ADDENDUM No. 5 - February 3, 2016

Nelson Place Elementary School

CLIENT INFORMATION:
Worcester Public Schools
City of Worcester
Massachusetts, 01605

DRAWING NUMBER:
ADD-5
H-001

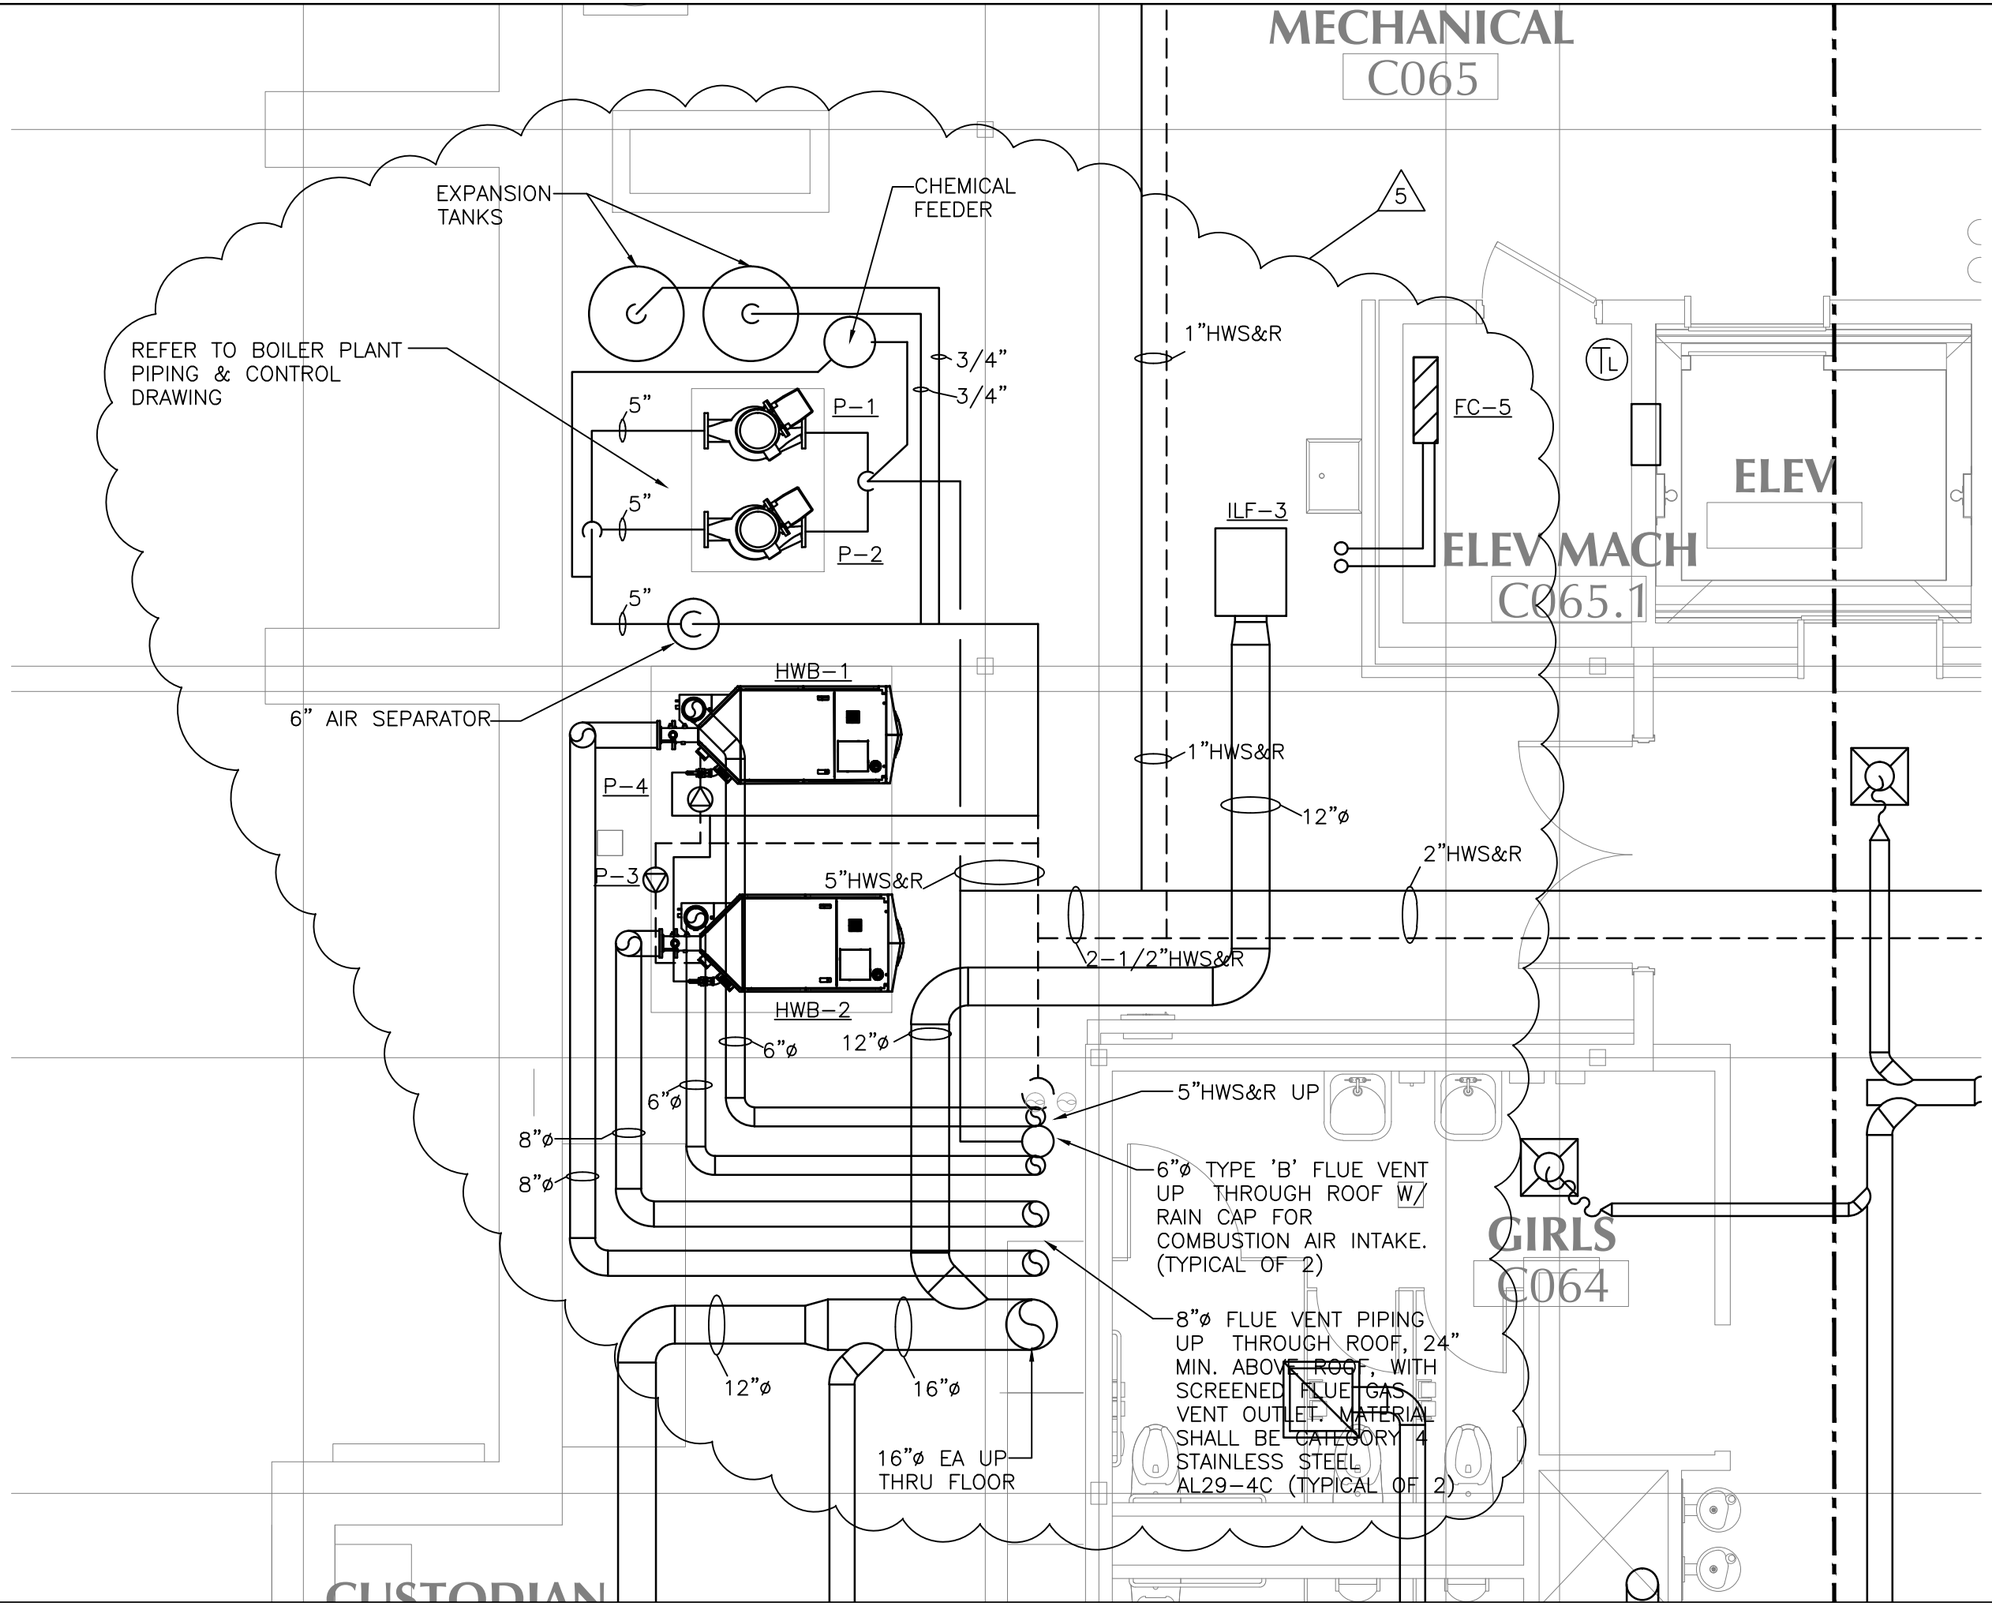
A. Refer to ADD-5/H-001.

DRAWING NUMBER:
ADD-5
H-002

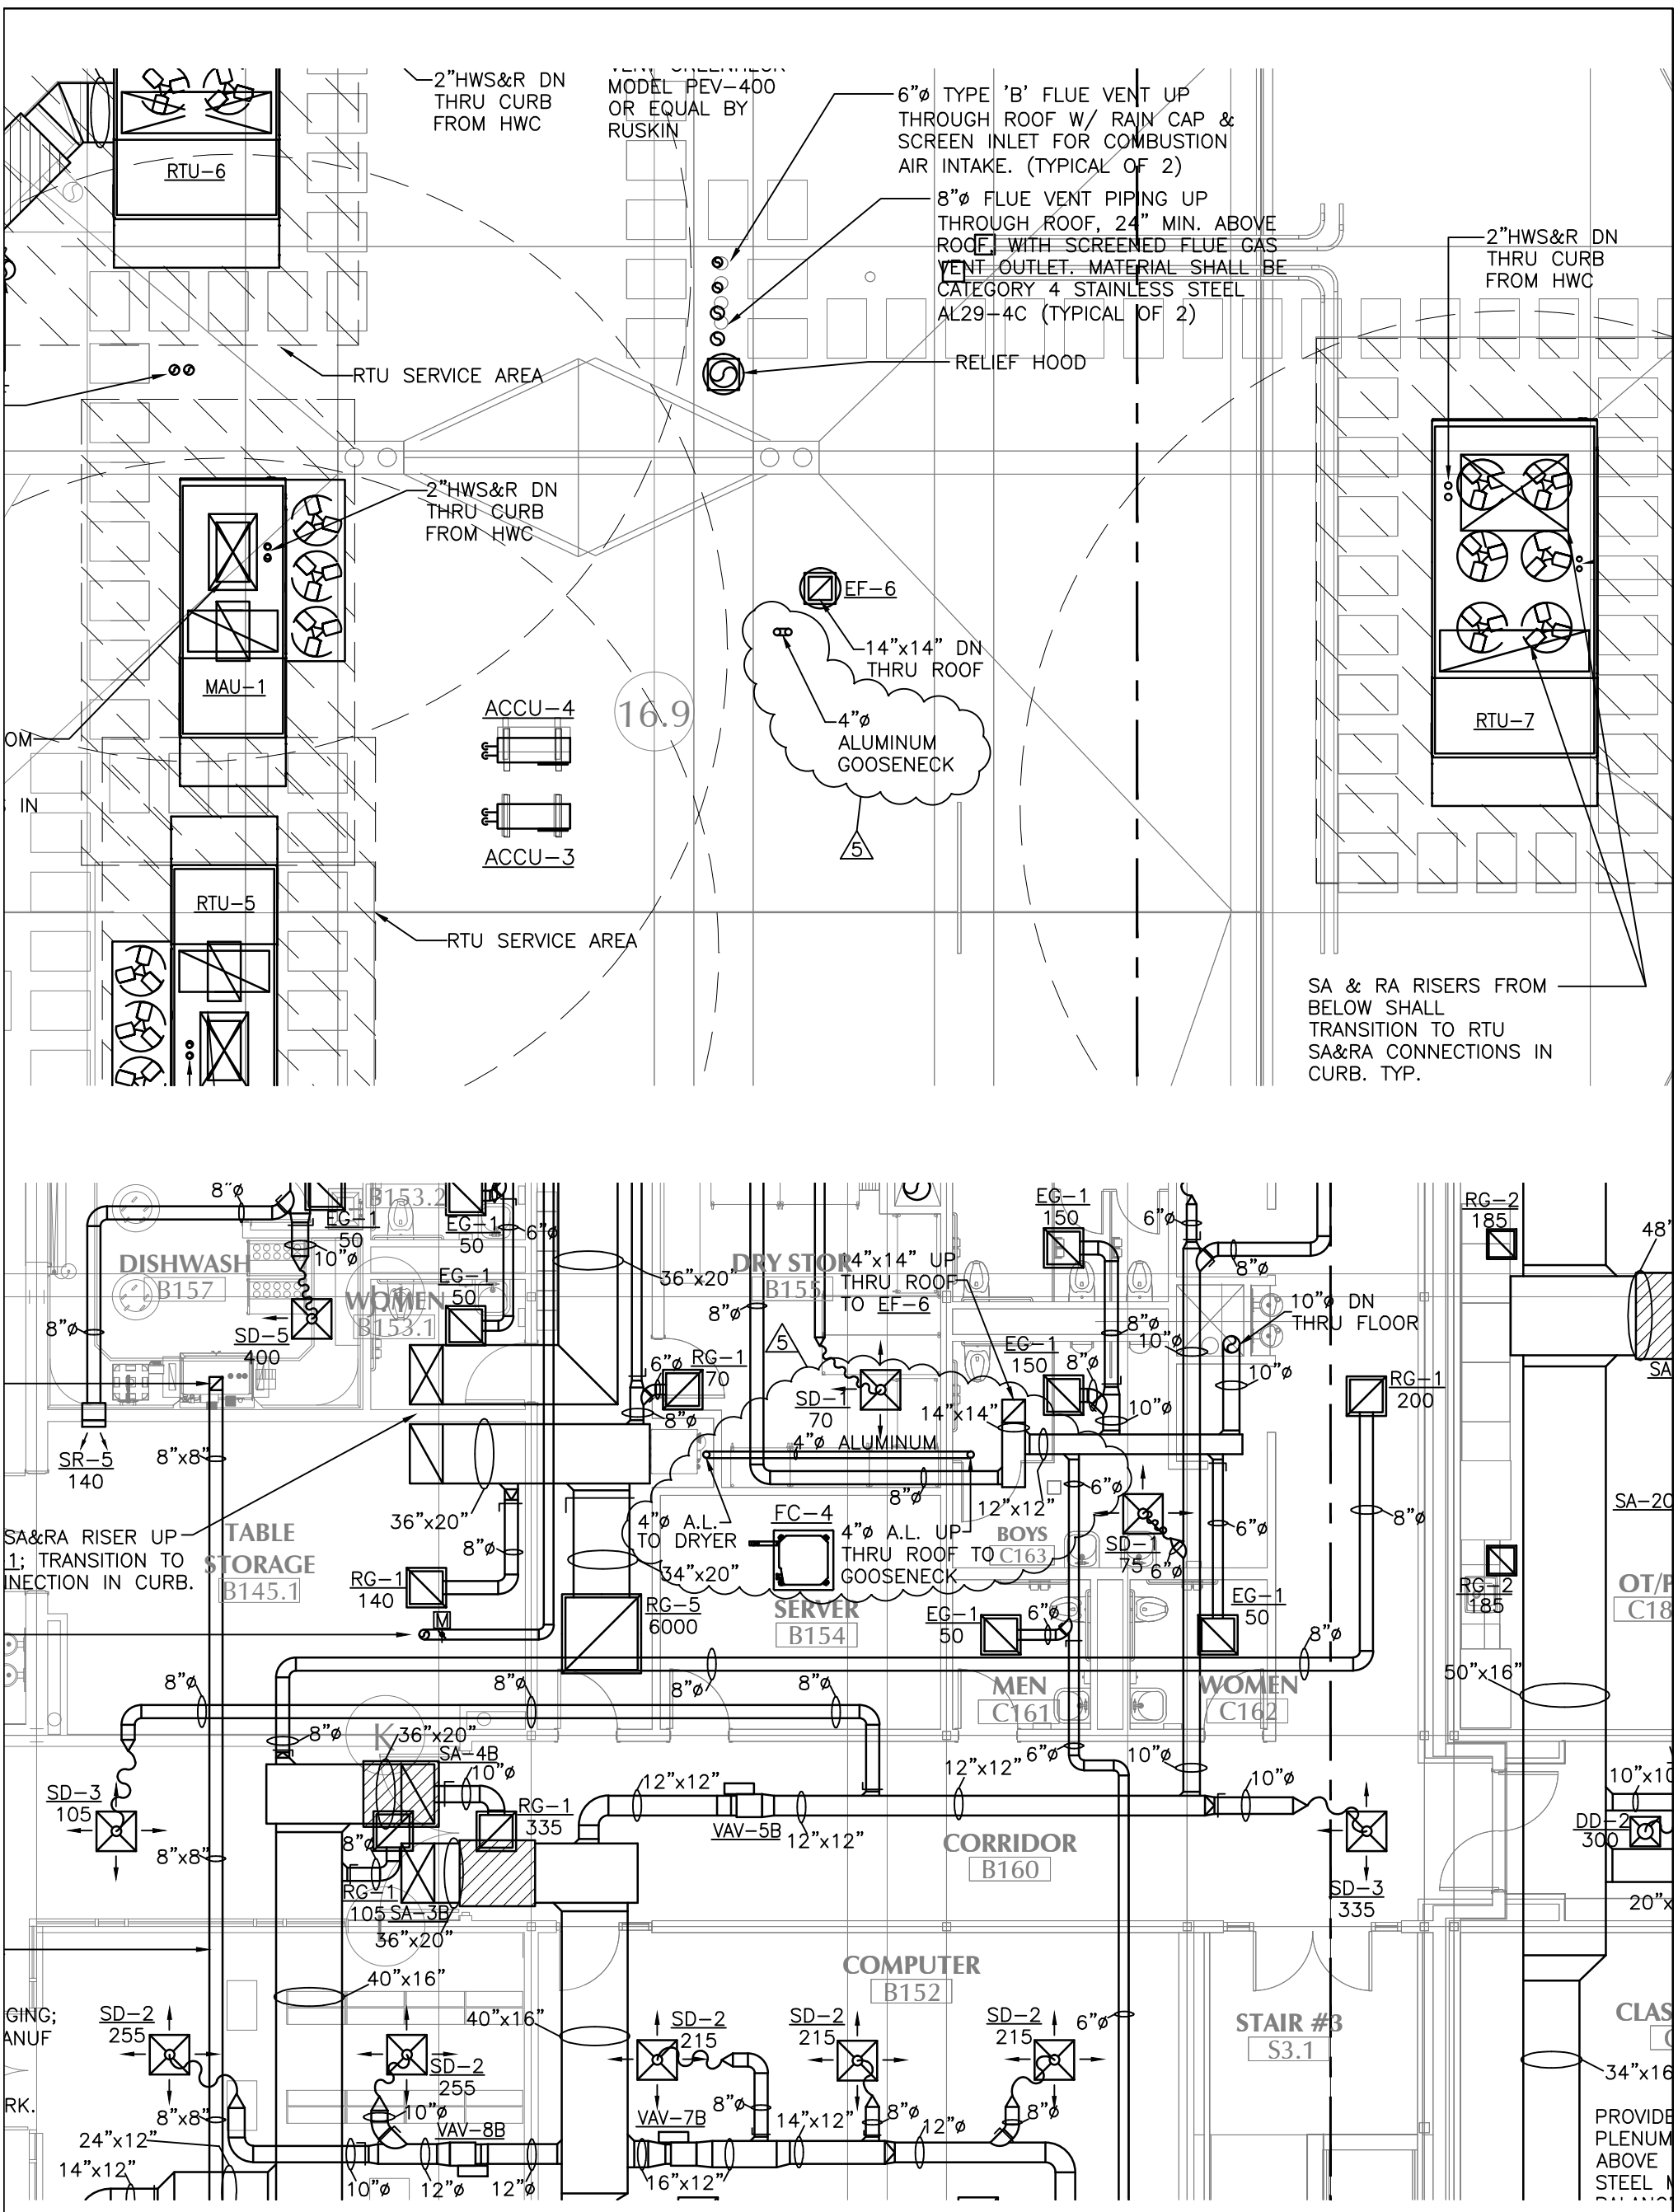
A. Refer to ADD-5/H-002.
B. Refer to ADD-5/H-003.

A. Refer to ADD-5/H-002.

DRAWING NAME: Electrical - Kitchen Plan	SHEET REF. NO. E2.9
DATE: 02/03/16	DRAWING NUMBER: ADD5
SCALE: 1/4" = 1'-0"	SKE-005
REFERENCE: ADD5

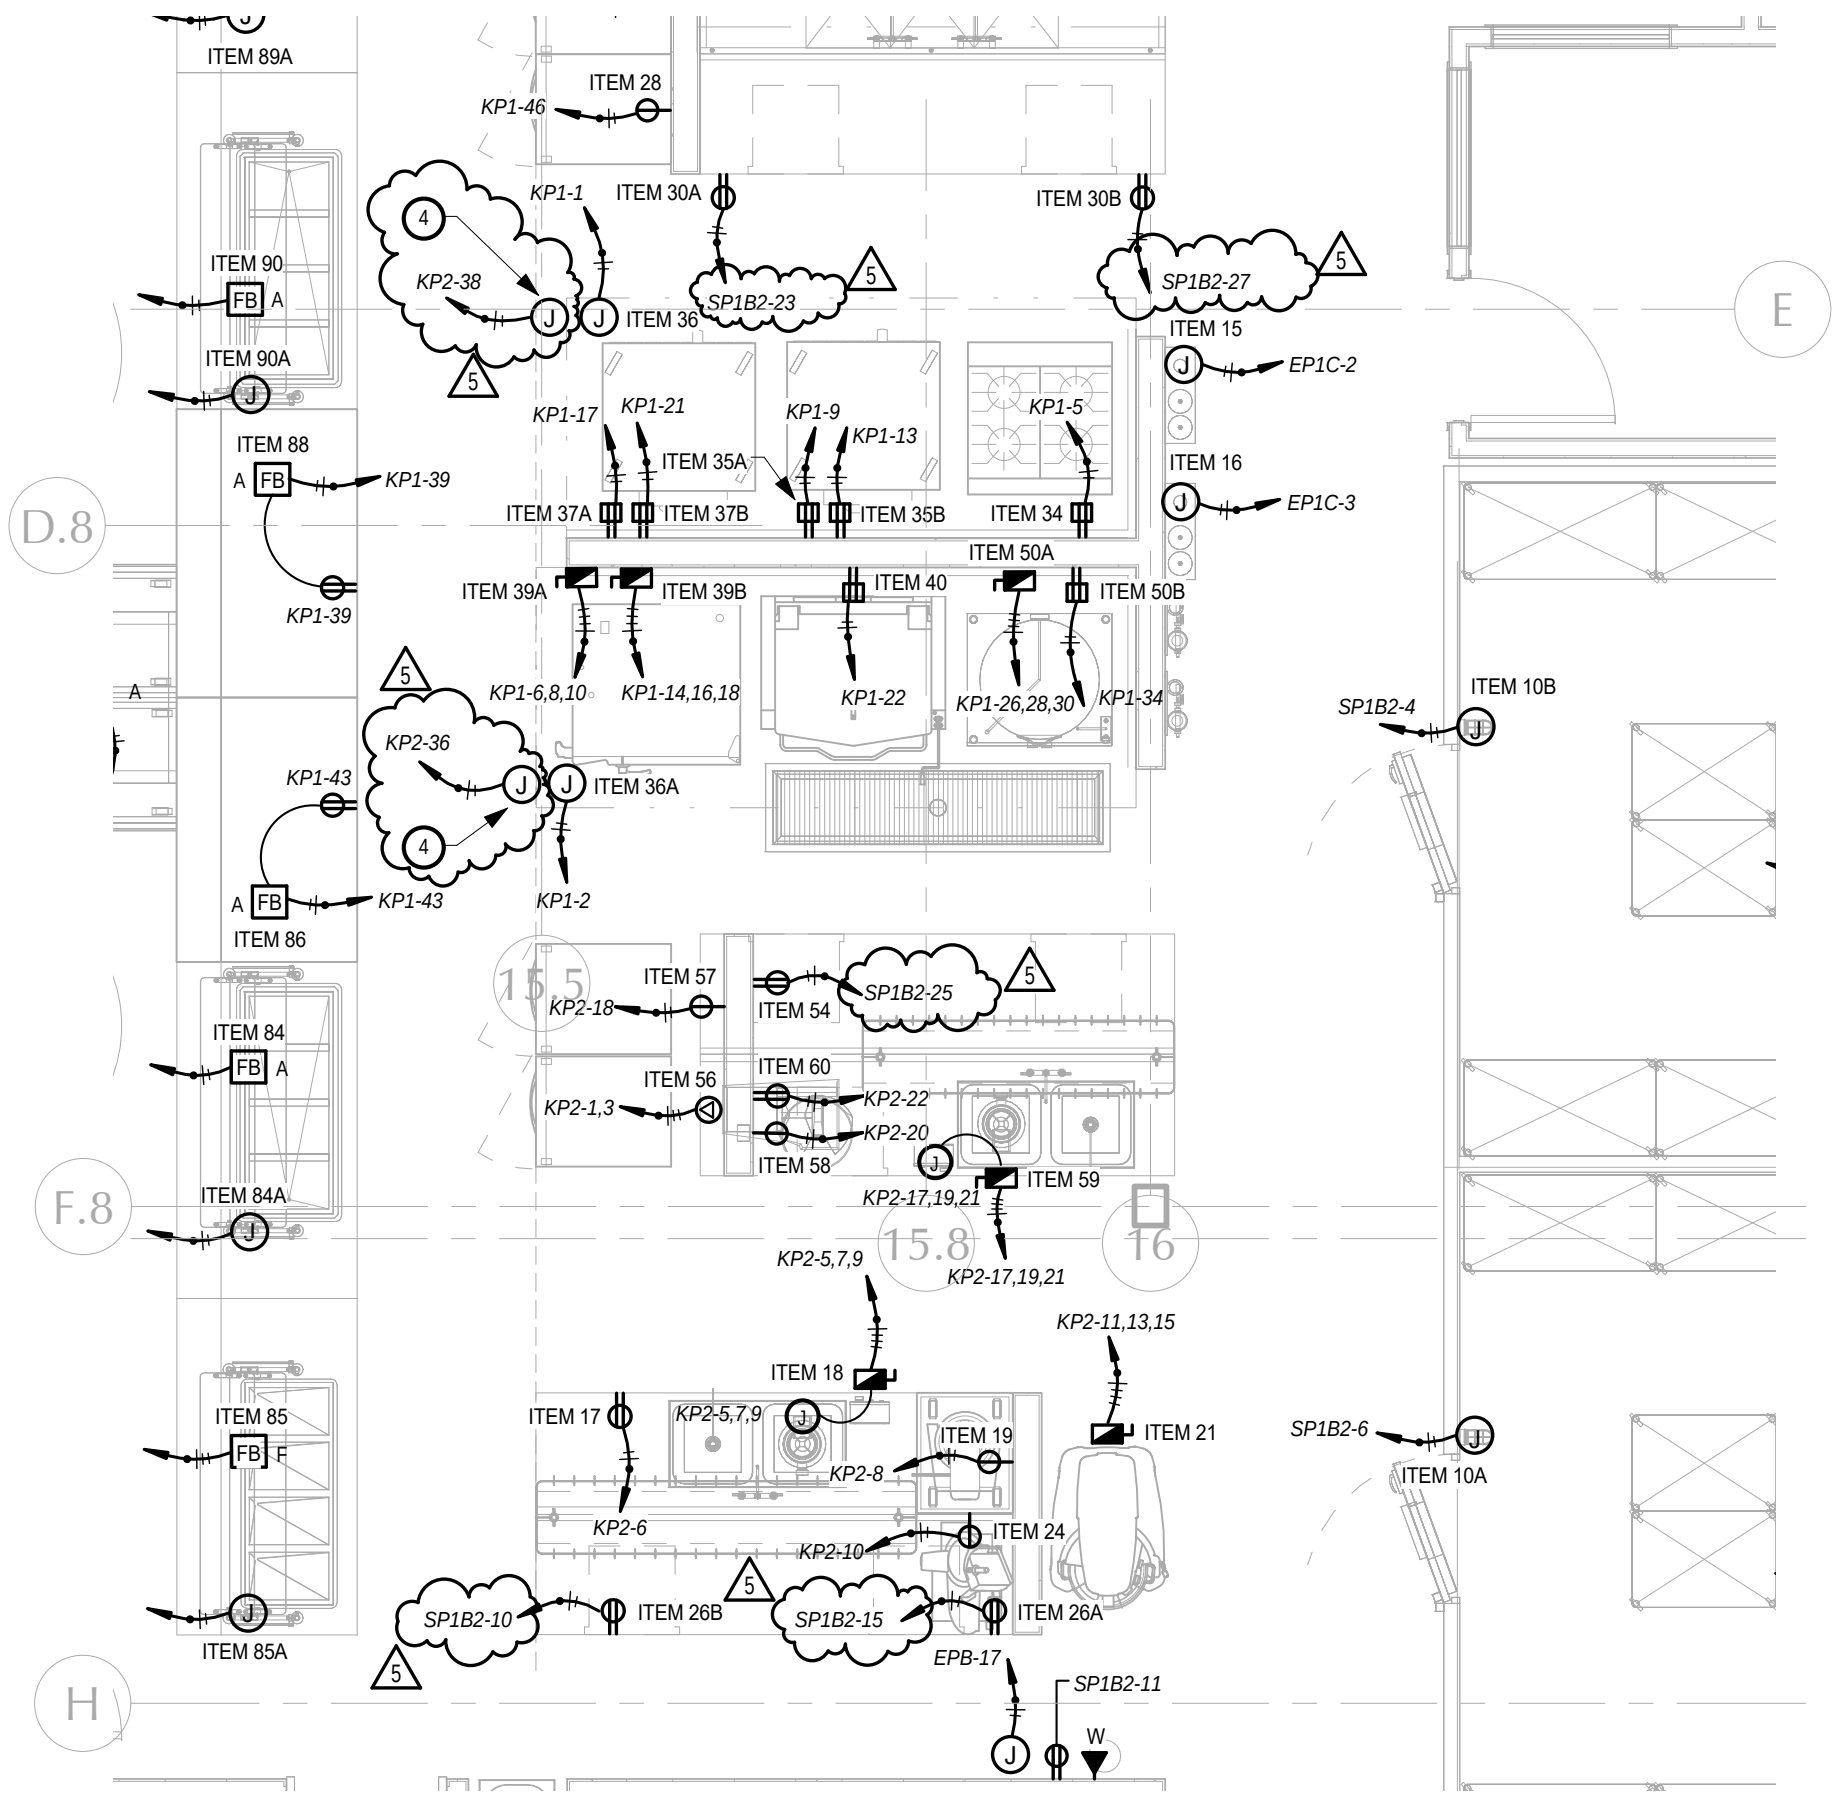
1. ADD POWER FOR KITCHEN EXHAUST FAN CONTROLLERS.
2. KEF-1 AND KEF-2 (LOCATED ON ROOF), SHALL BE WIRED VIA VFDs (480V-3PH) IN KITCHEN EXHAUST FAN CONTROLLER (KEFC) LOCATED BY THE EXHAUST HOOD IN THE KITCHEN, ABOVE CEILING. ELECTRICAL CONTRACTOR SHALL INSTALL THE VFDs IN THE KEFC, TOTAL OF TWO VFDs ARE REQUIRED, ONE FOR EACH KEFC. VFDs ARE TO BE FURNISHED BY OTHERS.
3. ITEMS 26A, 26B, 30A, 30B, AND 54 SHALL BE POWERED FROM PANEL SP1B2. PROVIDE GFCI CIRCUIT BREAKERS FOR THESE ITEMS.
